# Addendum

**PROJECT:** City of Springfield, Fire Station No. 5

## **ADDENDUM NO. 4**

DATE	08/29/2024
JOB NO.	4088.03
DRAWN	AEE/MSM
CHECKED	CMS
COPYRIGHT © 2024 - App Architecture, Inc.	
TITLE <b>REFLECTED CEILING PLAN</b>	
SHEET NO. <b>A2.11</b>

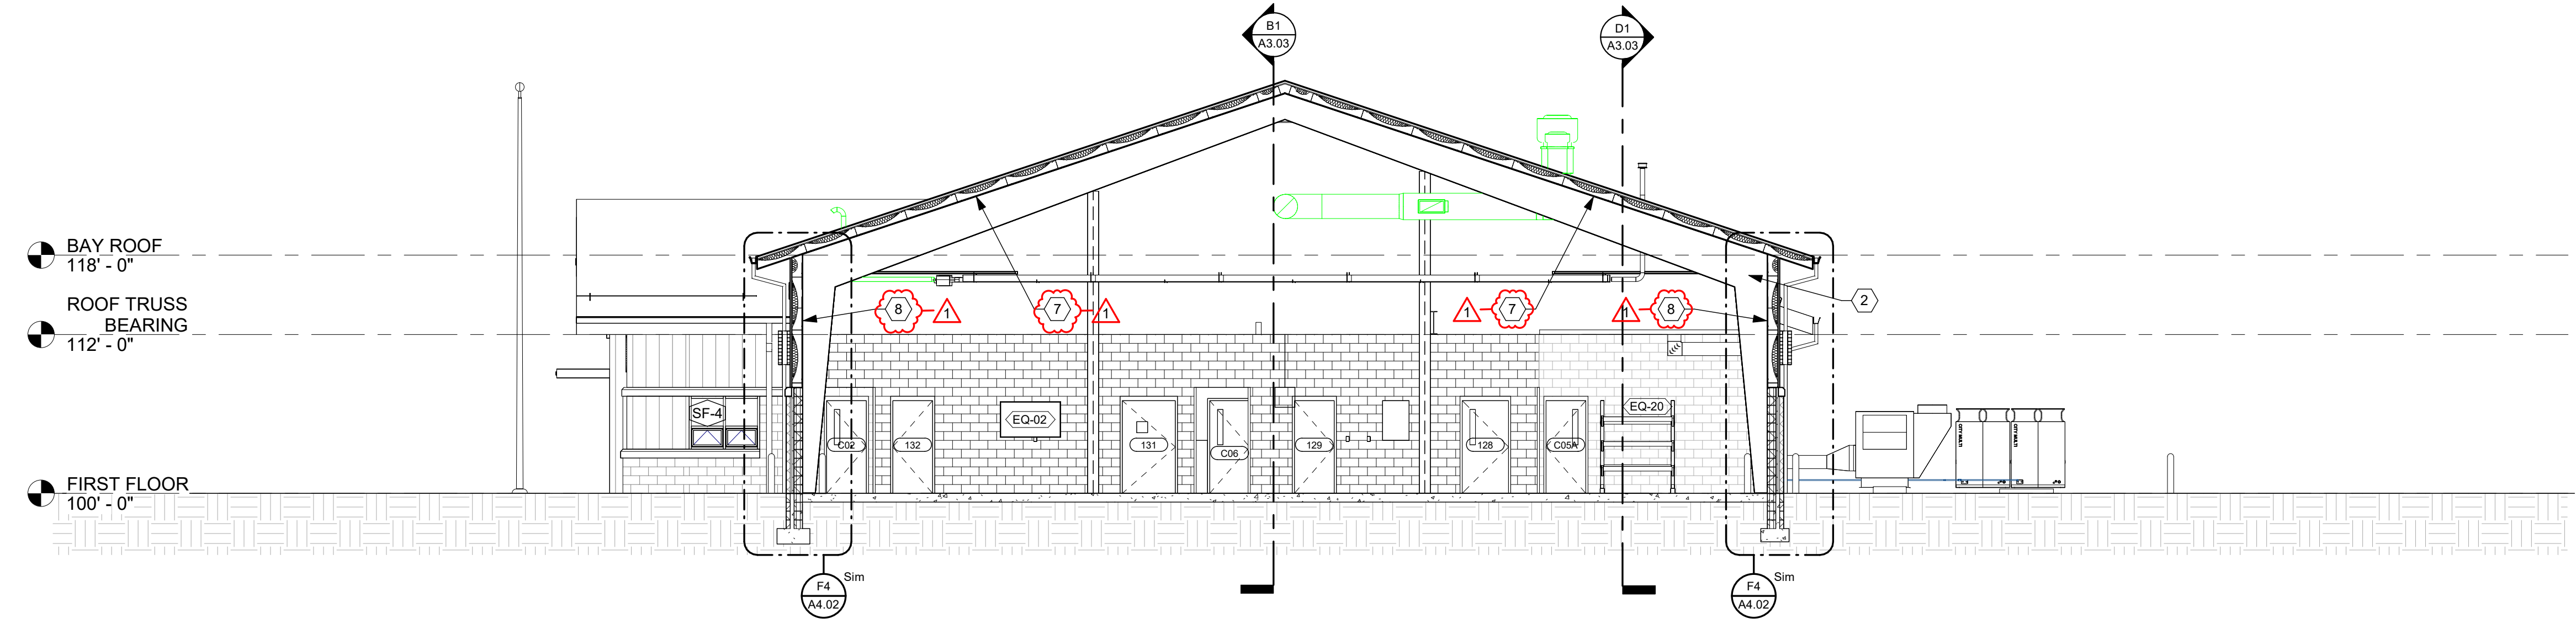
2. Sheet not reissued.
- ITEM A3 SHEET A2.11 – REFLECTED CEILING PLAN
1. Construction Note 1 revised to indicate liner panels attached to the underside of the girts at the roof of the apparatus bays.

SHEET NO.  
**A3.02**

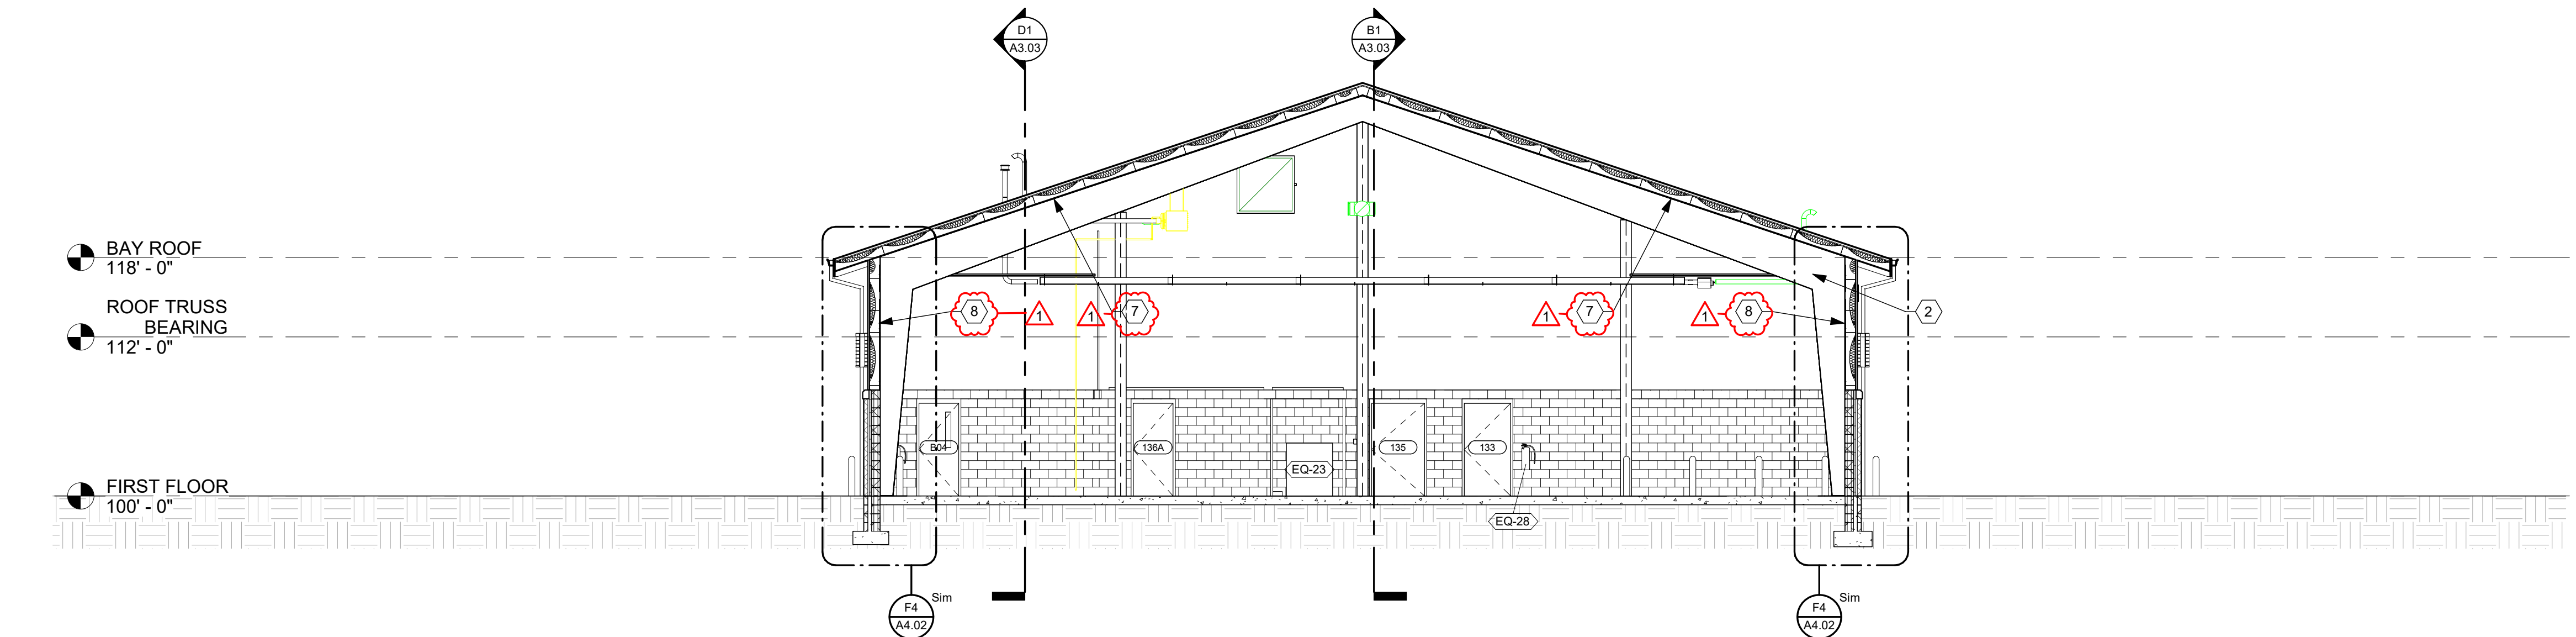
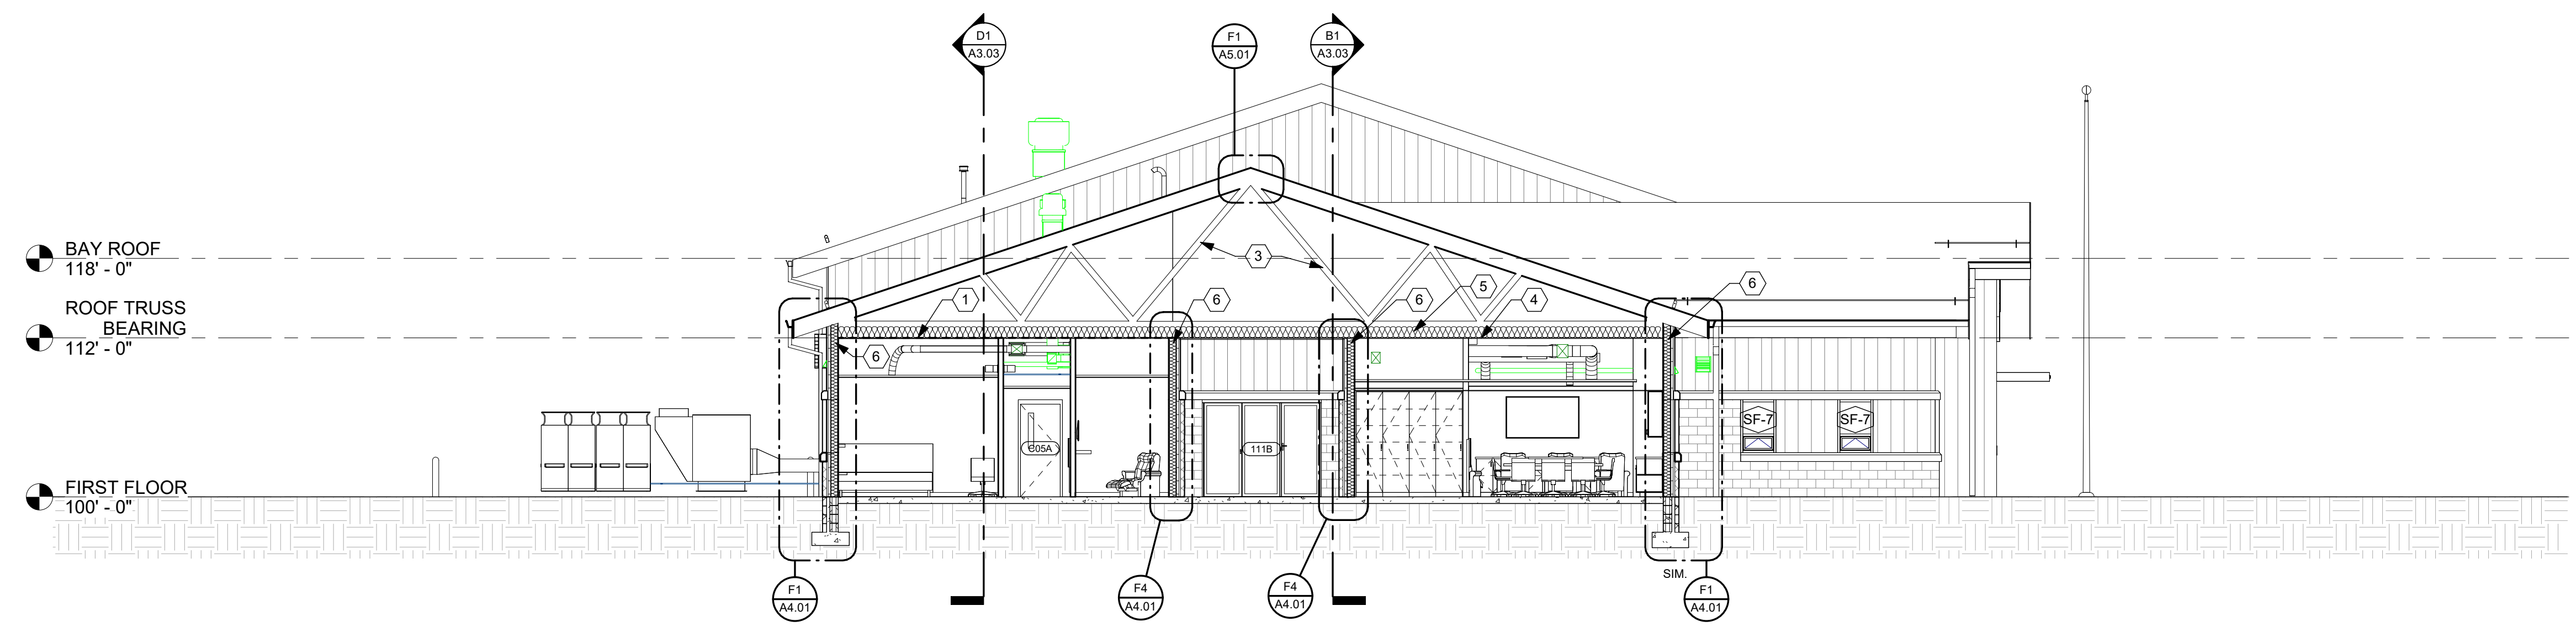
- ITEM A4 SHEET A3.02 – BUILDING SECTIONS
1. Construction Notes 7 & 8 added to the sheets to call out liner panels in the apparatus bays.
- ITEMS A5 SHEET A3.03 – BUILDING SECTIONS

SHEET NO.  
**A3.03**

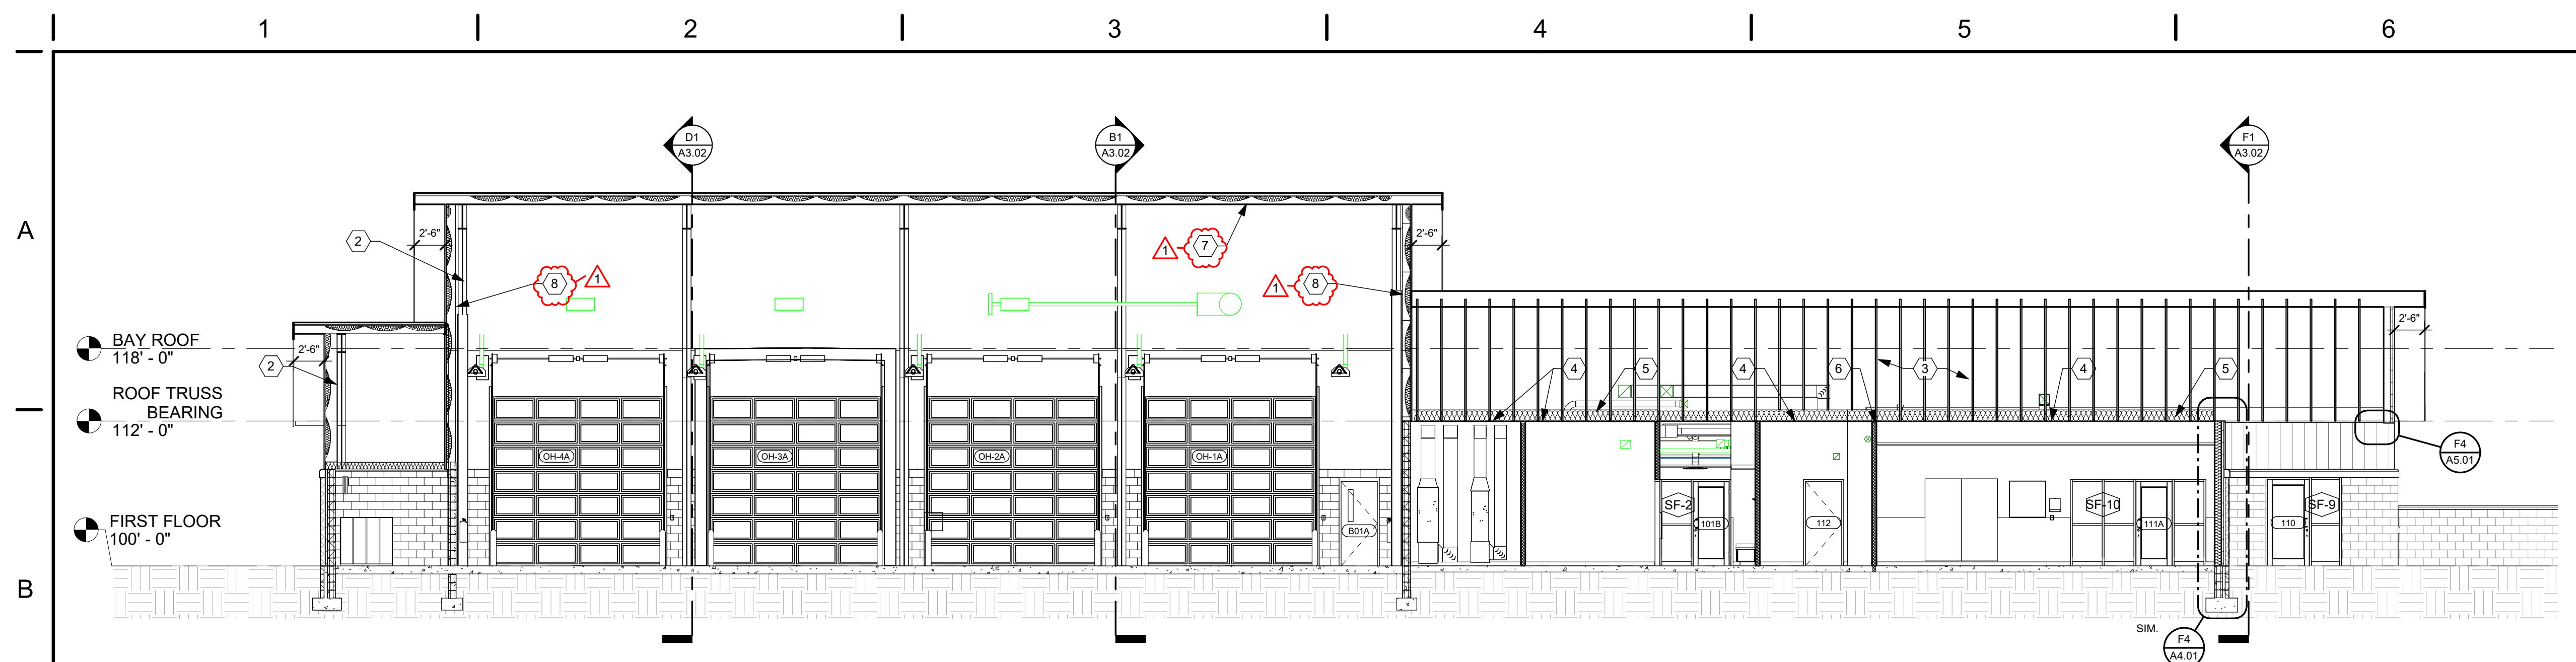
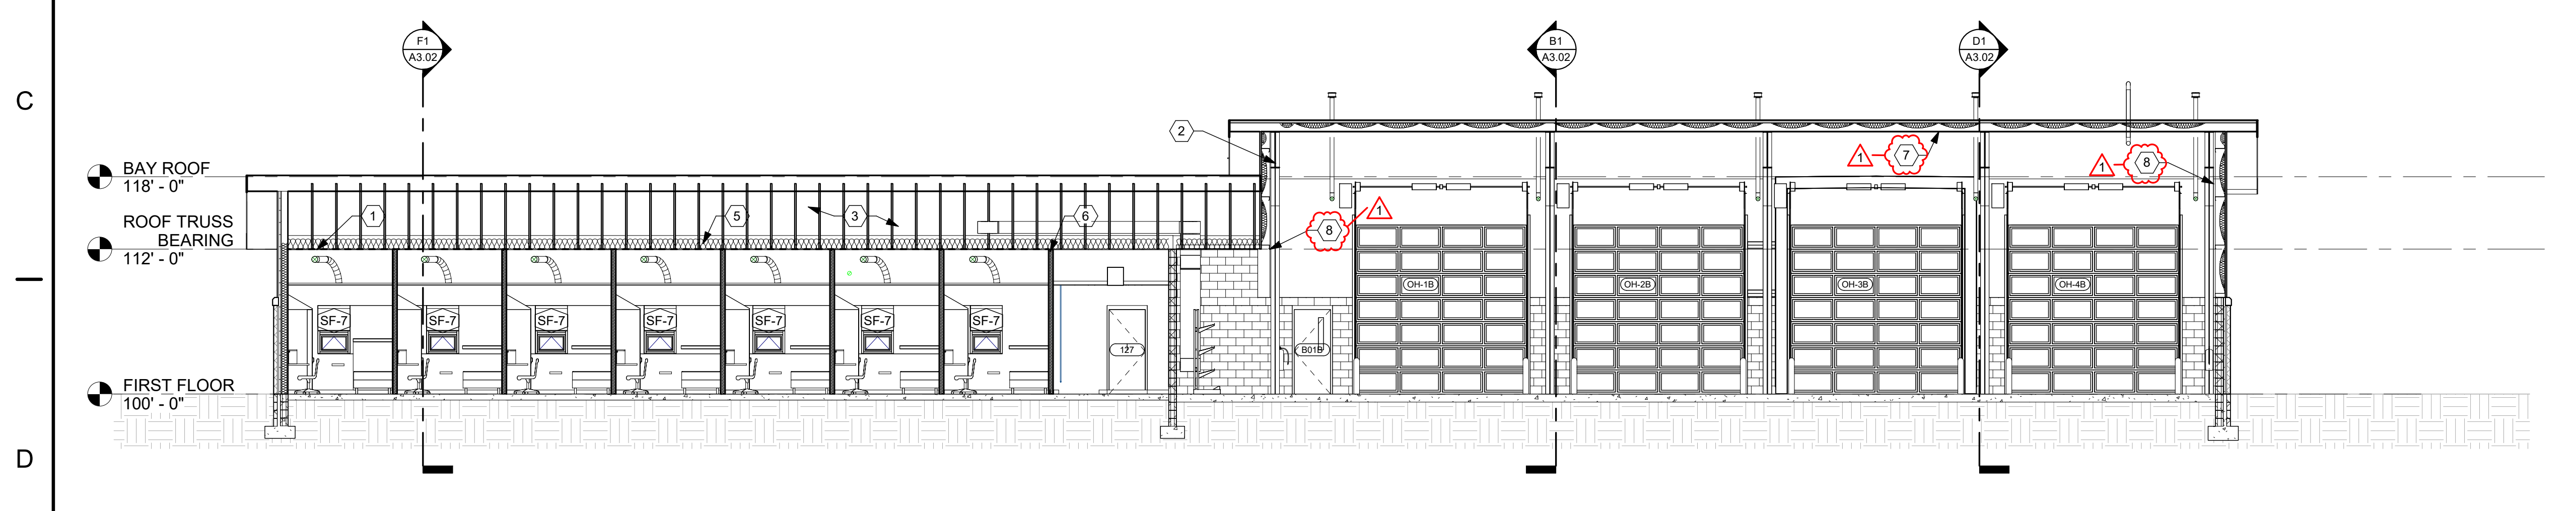
1. Construction Notes 7 & 8 added to the sheets to call out liner panels in the apparatus bays.
- ITEM A6 SHEET A4.02 – WALL SECTIONS
1. Wall Section F4 revised to show liner panels.

COPYRIGHT © 2024 - App Architecture, Inc.  
TITLE  
**EXTERIOR DETAILS - ROOF**

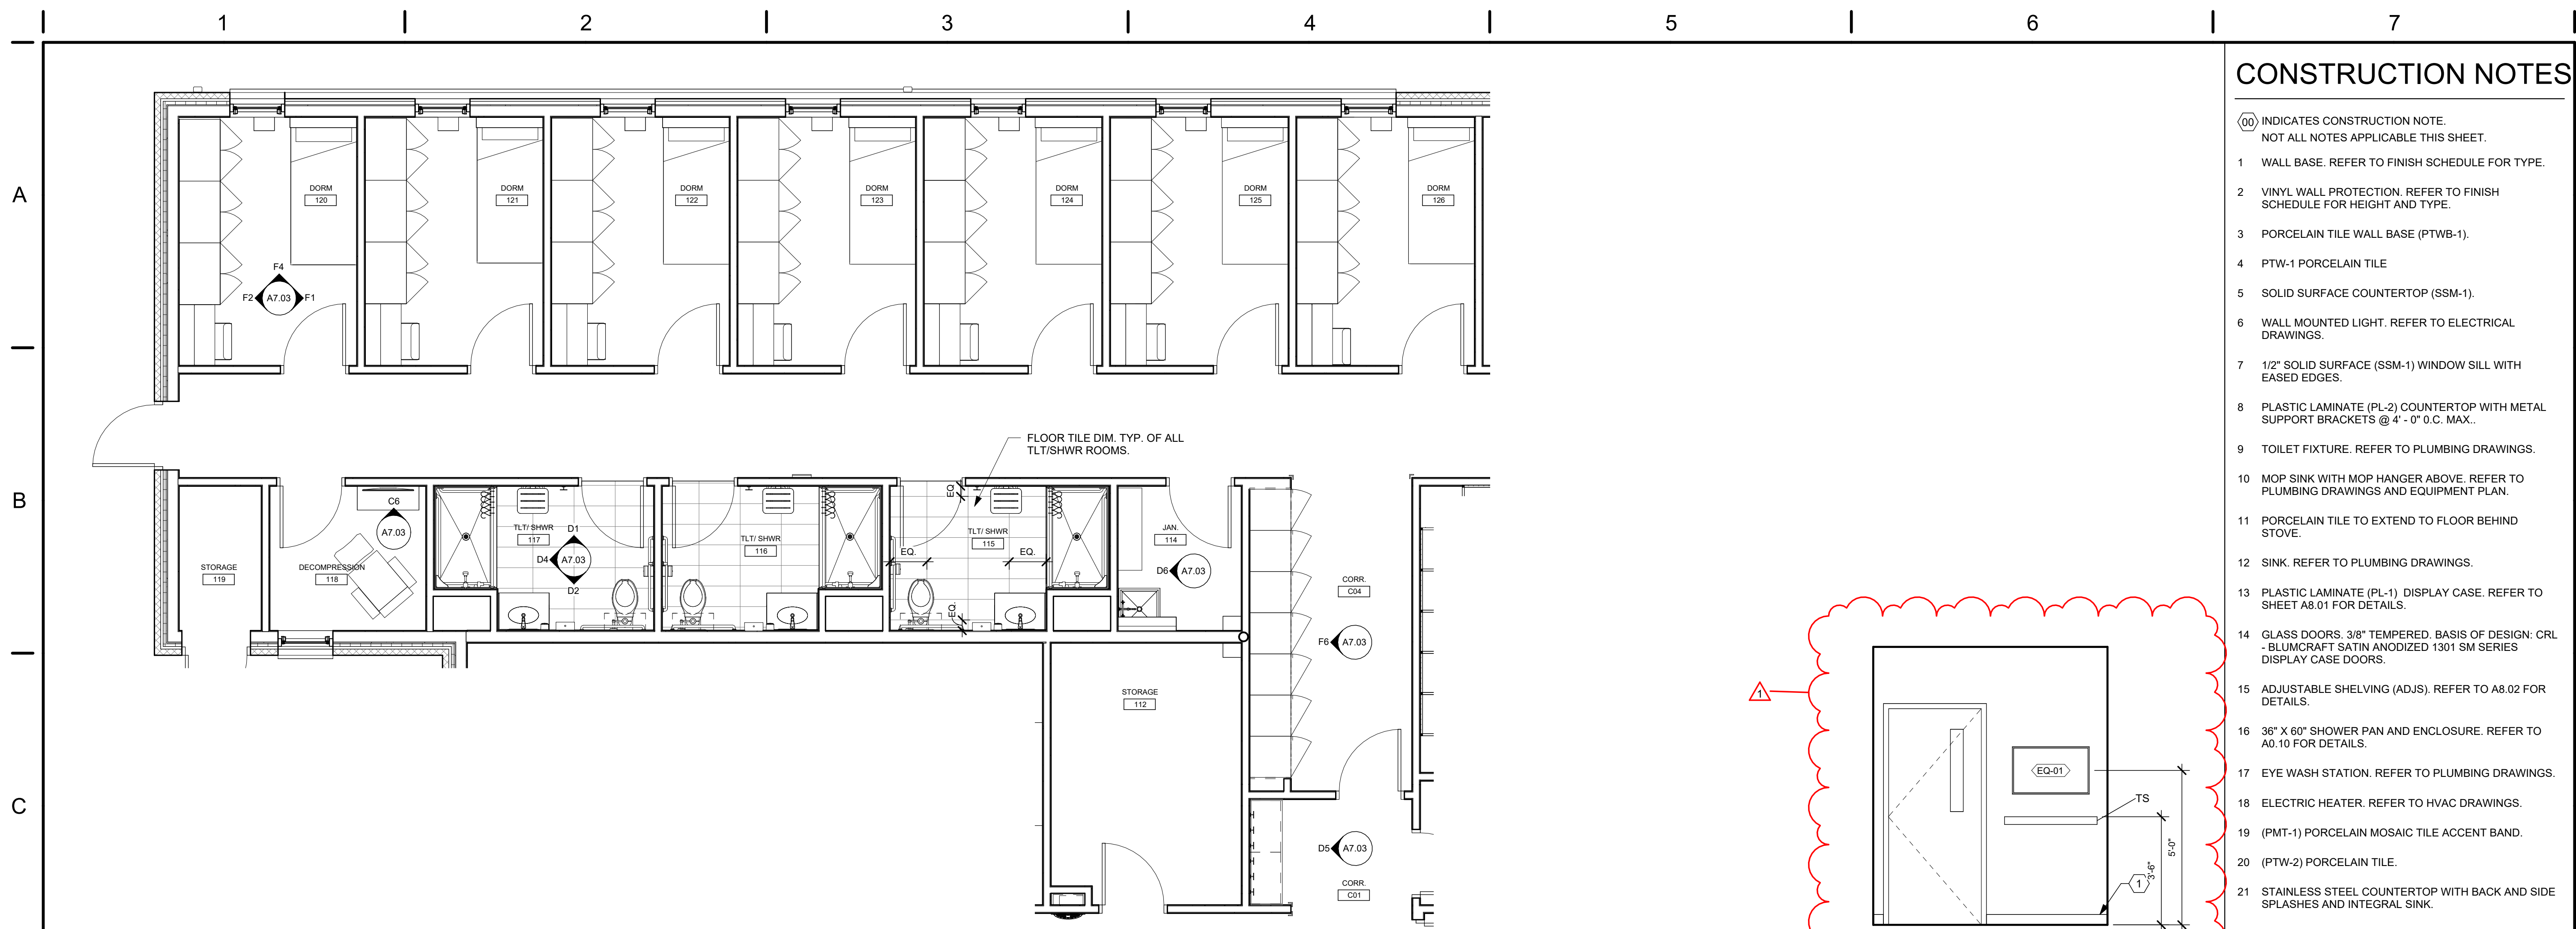
- Q1: Details D1 and D4 on sheet A5.01 show blocking and framing at the bay eave. Please provide details showing how these materials install to the PEMB structure

- ITEM A7 SHEET A5.01 – EXTERIOR DETAILS ROOF
1. Detail D4 revised to show liner panels.
- ITEM A8 SHEET A7.03 – INTERIOR ELEVATIONS
1. Added elevation C6 at 118 Decompression room.

- A1: D1/A5.01 is the eave detail at the conventional metal stud and truss condition at the living quarters. D4/A5.01 is the eave detail at the PEMB structure for the apparatus bays. The PEMB structure is delegated design. The final eave details will need to be coordinated with the PEMB manufacturer. D4/A5.01 shows the intent.
